environmental statement

INDIAN POINT NUCLEAR GENERATING PLANT UNIT NO. 3

DOCKET NO. 50-286

February 1975

Fig. III-2. Schematic representation of Indian Point Plant cooling water systems.

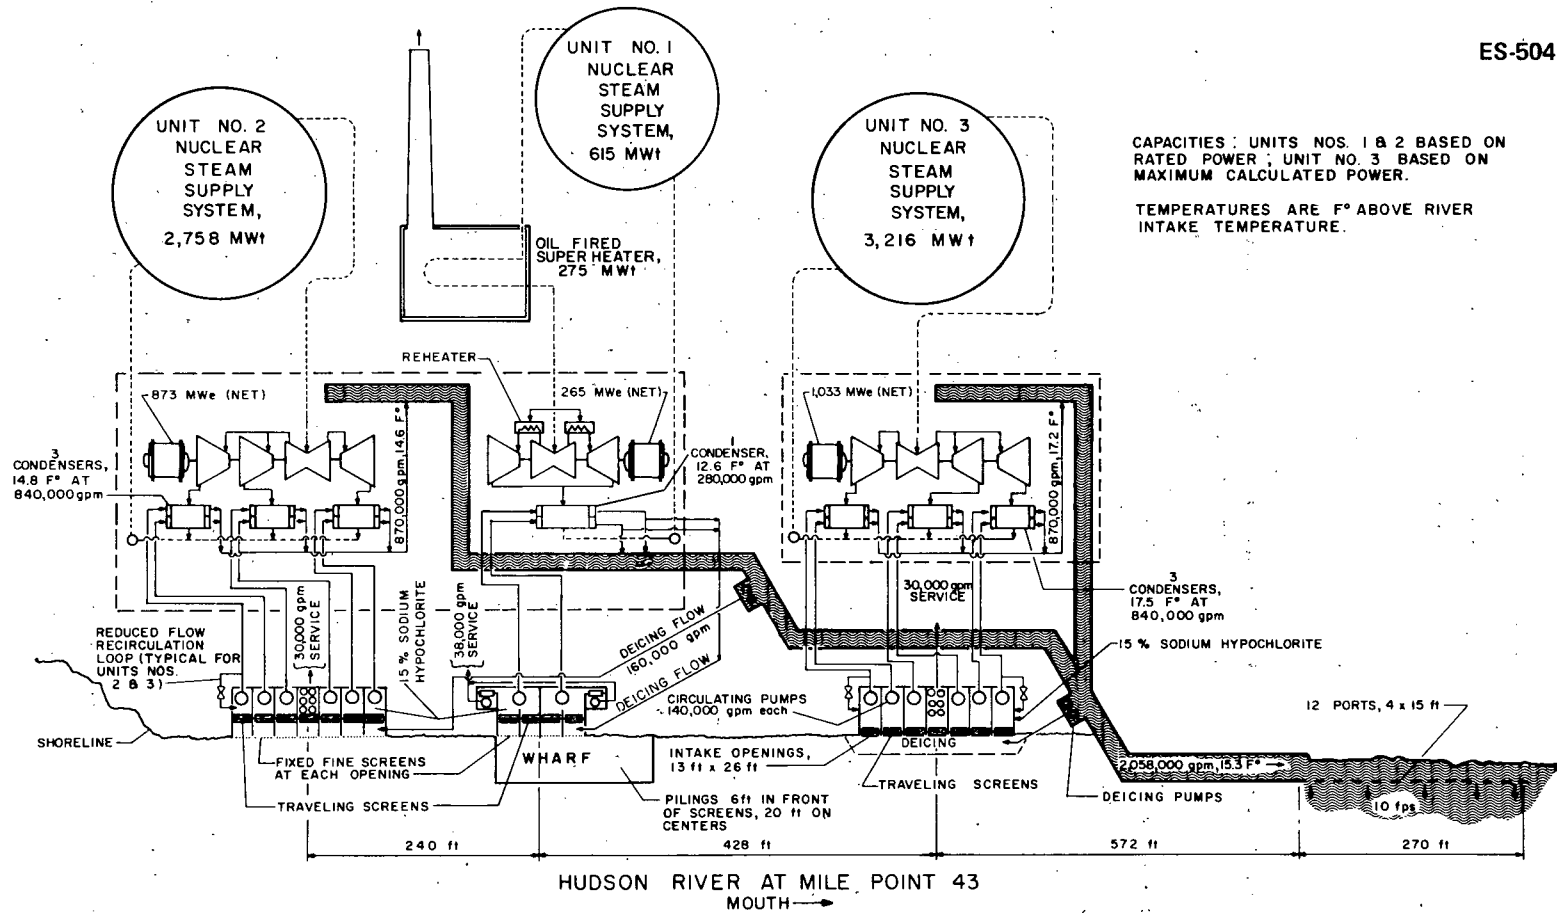
26. Because of lack of space on the drawing for Figure III-2, it is judged sufficient to label the effluent from the service water pumps as "service."
27. Line 3 of the second paragraph on page III-6 of the DES states that there is one intake service water structure for Unit No. 3. This structure is provided with six service water pumps and thus several service pumps are available for washing the traveling screens if one or two service pumps are out of commission.

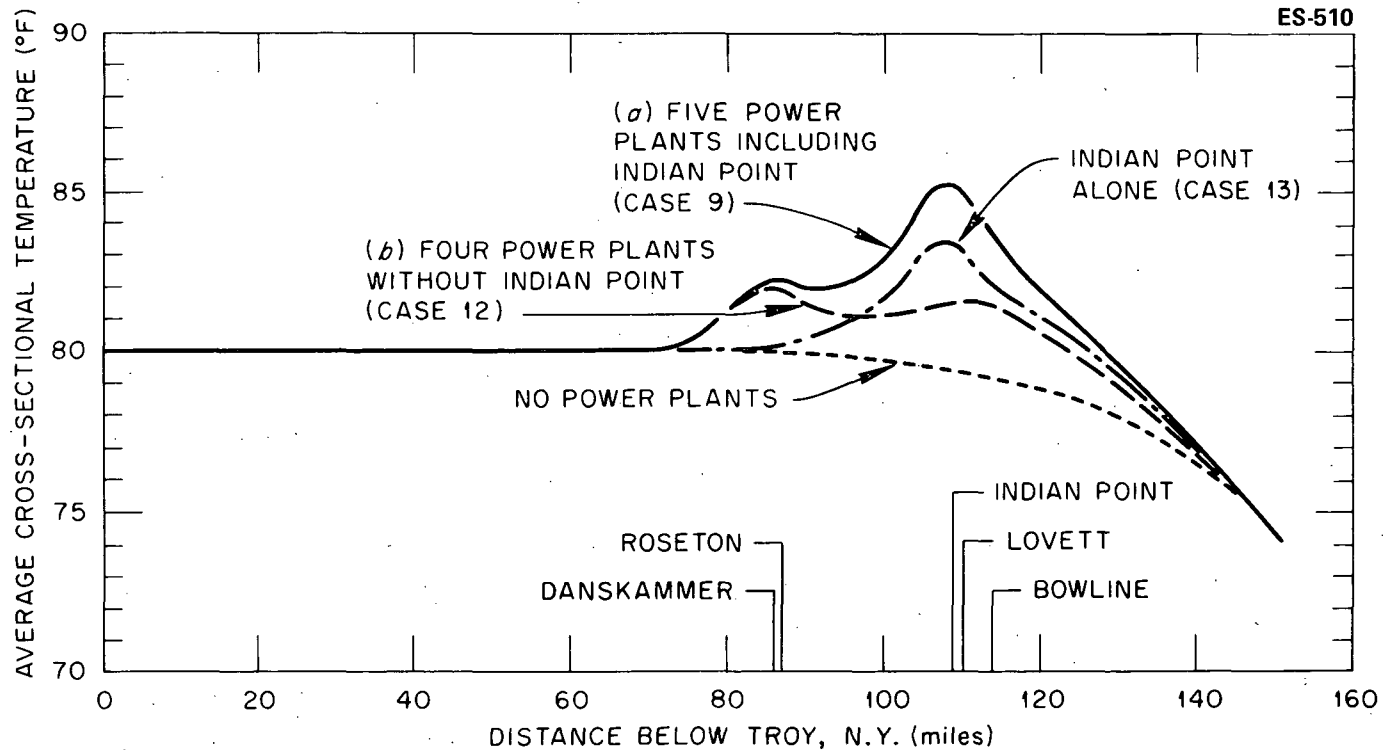
In an earlier AEC impact statement issued on Indian Point Unit 2, it was recognized that fish impingement rates are a function of both flow and velocity through the intake structure. Figure V-4 in the present draft statement (which was also presented in a previous statement for Unit 2), illustrates this point. It can be seen that the impingement rate increases drastically at the plant site for velocities greater than 0.9 fps (0.28 mps). The intake velocity across the screens at Unit 3 will be 1.5-2.0 fps (0.46-0.61 mps) under full flow conditions. The question then arises as to why the applicant did not utilize such information in the final design of the intake structure. A better design could have resulted in an intake configuration with a lower intake velocity and consequently a reduced impingement rate.

A curve has been added to Figure V-4 showing the calculated river temperature if the upper reaches are at 80°F, the Battery temperature is 74°F, the fresh-water flow rate is 4,000 cfs, and there are no heat discharges into the river from the power stations. This curve may be used for reference in examining the calculated temperatures along the river when the power stations are rejecting heat, because all of these studies were based on 80°F upper reach and 74°F Battery temperatures. However, the staff does not intend that

The curve shown in Figure V-4 was not originally included by the staff because, as can be noted in the figure, the calculated effect of the assumed temperature at the Battery does not extend upstream far enough to appreciably influence the "ambient" temperature at Indian Point, and for purposes of evaluation of the temperature rises at Indian Point, the calculated temperatures can be compared to 80°F as a base.
